Moorebank Precinct West Concept Proposal

*State Significant
Development
Modification Assessment
(SSD 5066 MOD 1)
May 2019*

Figure 14 | Approved Layout (source: EIS Rts May 2015) and Modification Layout (source MOD SRts August 2017)

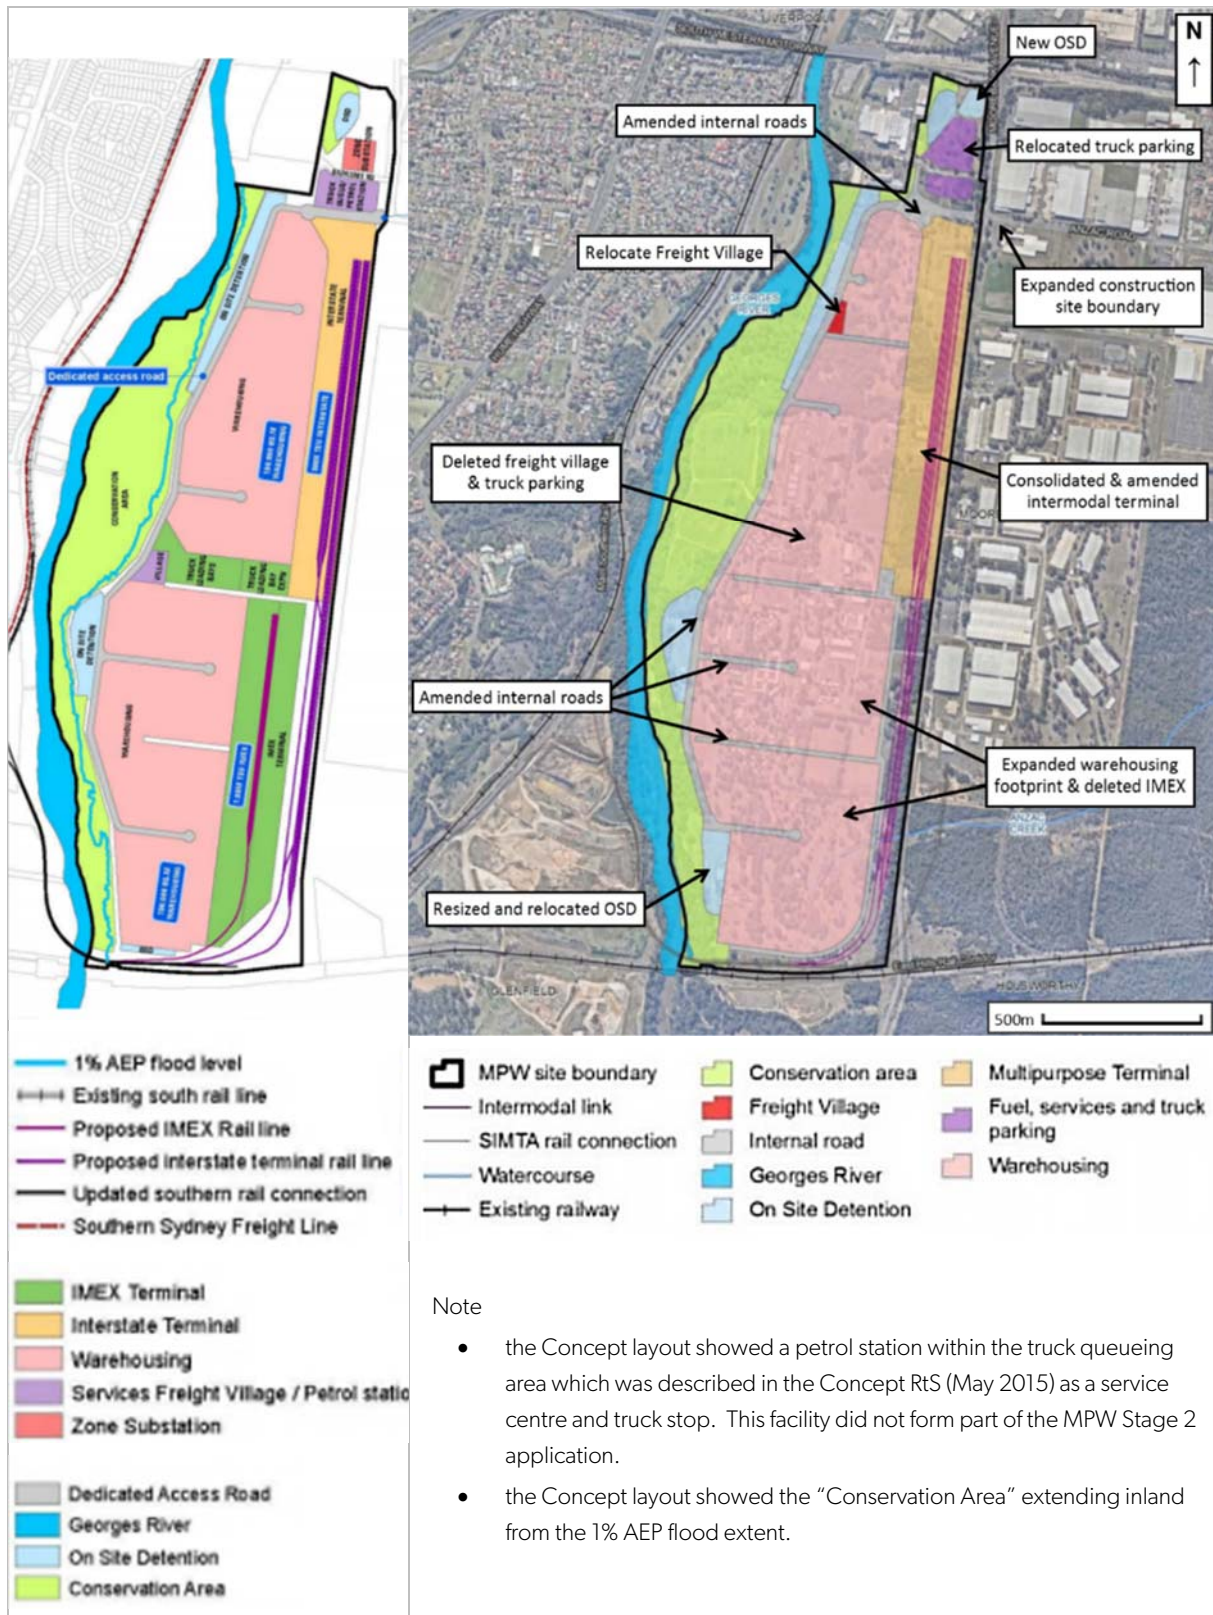
Figure 14 shows the approved layout and modified layout with:

- expanded construction footprint at the Moorebank Avenue/ Anzac Road intersection
- larger southern OSD basin relocated adjacent to (potentially encroaching into) the riparian corridor/ conservation area
- additional OSD basin in the north-east corner
- freight village relocated further north
- amended internal road layout
- truck parking relocated to the north of the site
- one rail terminal (northern terminal with one additional arrival/ departure rail track)
- warehousing extending over the footprint of the previously approved southern rail terminal and truck parking area.

Key issues associated with the modified layout, expanded footprint and transfer of containers between the MPW and MPE sites are:

Figure 17 | Modification Staging (source: Additional Information Response, Arcadis 14/03/2017)

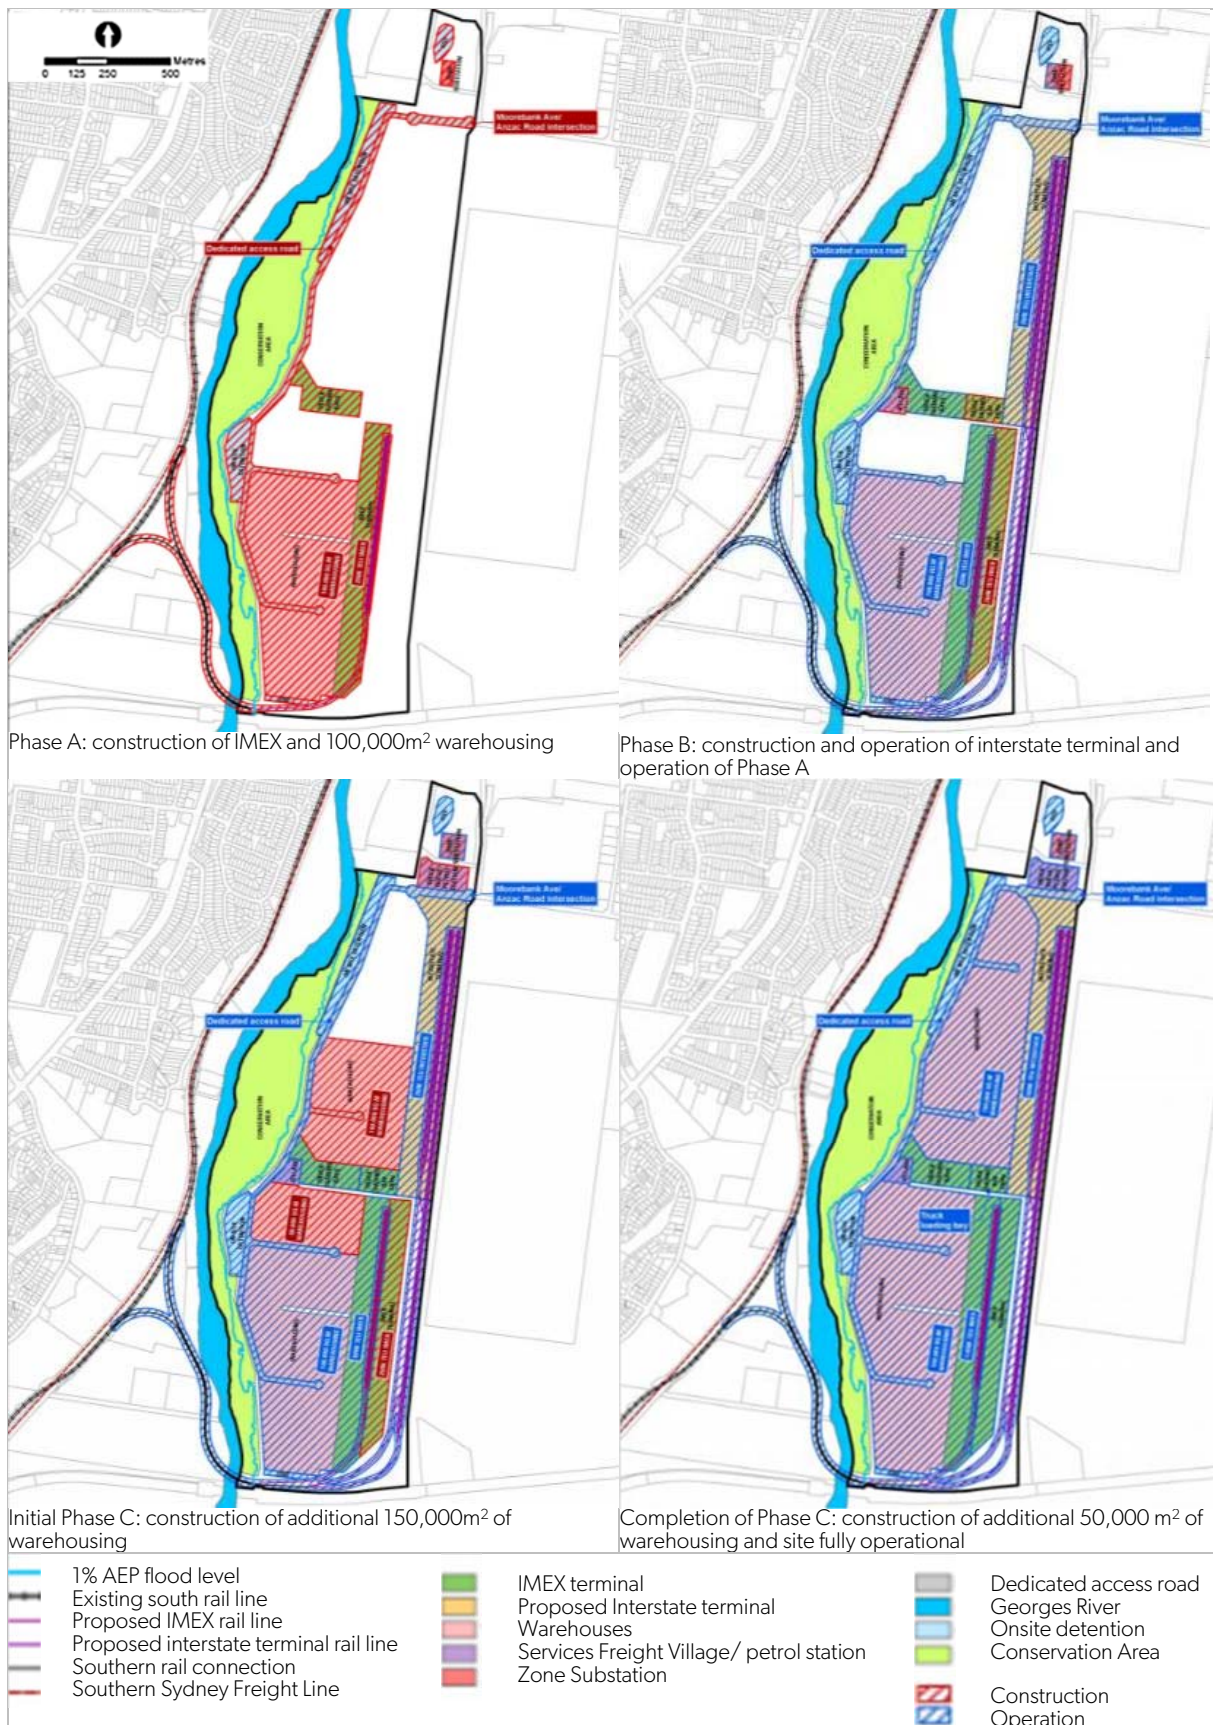
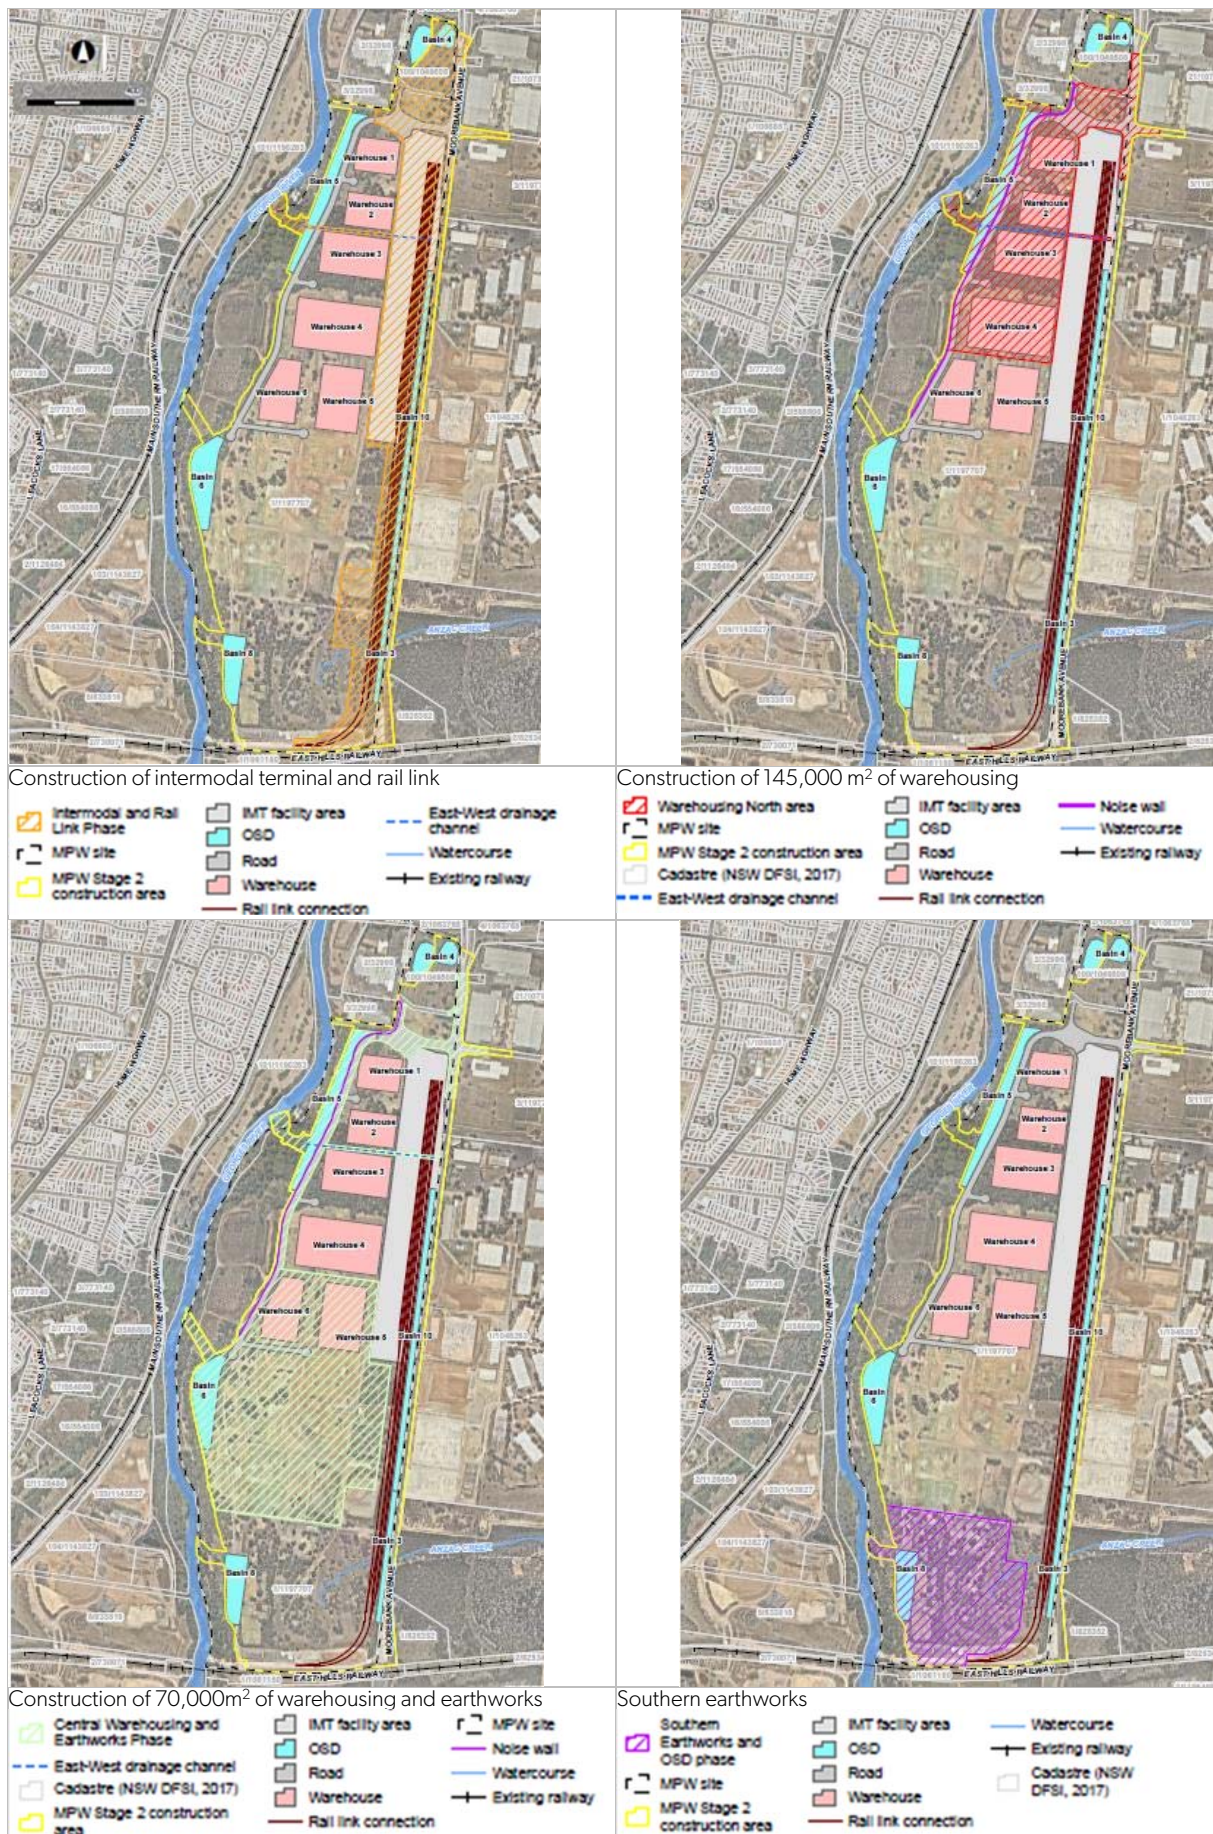
- impacted smaller areas of the site at any one time
- progressed from south to north (the MPW Stage 2 Application shows warehouse construction progressing from north to south, see **Figure 17**)
- showed sequential infrastructure and warehouse estate construction and operation
- included concurrent operation of completed warehousing and construction of subsequent warehouse phases.

In addition, the Department does not consider reliance on the Concept EIS assessment of impacts adequate because:

- the staged construction footprints have changed, construction activities have changed (fill importation and placement), the layout has changed and interaction between the MPW and MPE sites is proposed
- cumulative impacts need to be assessed using updated construction programs for both the MPW and MPE sites.

As noted in **Section 6.2.1**, the Department recommends a general condition requiring provision of staging details for all future applications. This condition also includes a requirement to document how the staging of development complies with all Concept conditions including those recommended for this Modification Application, e.g:
